SUBJECT: NuScale Power, LLC Response to NRC Request for Additional Information

No. 001 (RAI-10502 R1) on the NuScale Standard Design Approval

Application

NRC Question No.: FSR.LTR-1

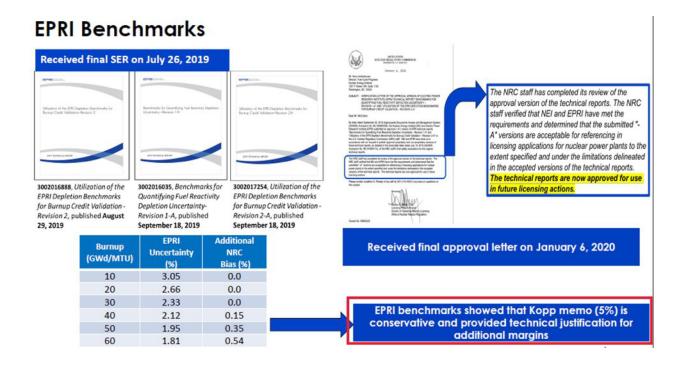
The applicant's criticality safety analysis in "NuScale US460 Fuel Storage Rack Design Topical Report," TR-145417-P, Revision 0, used TRITON/ORIGEN-S as the depletion code to estimate the post irradiated isotopic content of the fuel for utilization of burnup credit. To validate the depletion code, the applicant used 5% of the reactivity change from fresh unpoisoned fuel to the burnup of interest as the uncertainty, citing NEI 12-16, "Guidance for Performing Criticality Analyses of Fuel Storage at Light-Water Reactor Power Plants," Revision 4 (ML19269E069), Section 4.2.3 as justification.

NuScale is requested to provide equivalent justification for using the uncertainty equal to 5% of the reactivity decrement for its depletion uncertainty. Otherwise, NuScale can validate TRITON/ORIGEN-S in an alternate manner such as those described in NUREG-2215, "Standard Review Plan for Spent Fuel Dry Storage Systems and Facility – Final Report," (ML20121A190) and NUREG-2216, "Standard Review Plan for Transportation Packages for Spent Fuel and Radioactive Material: Final Report," (ML20234A651).

The 5% depletion uncertainty was first introduced in 1998 via an NRC memo from Senior Reactor Engineer Larry Kopp to Branch Chief Timothy Collins (i.e., the "Kopp memo"). The guidance is illustrative in its simplicity:

"In the absence of any other determination of the depletion uncertainty, an uncertainty equal to 5 percent of the reactivity to the burnup of interest is an acceptable assumption."
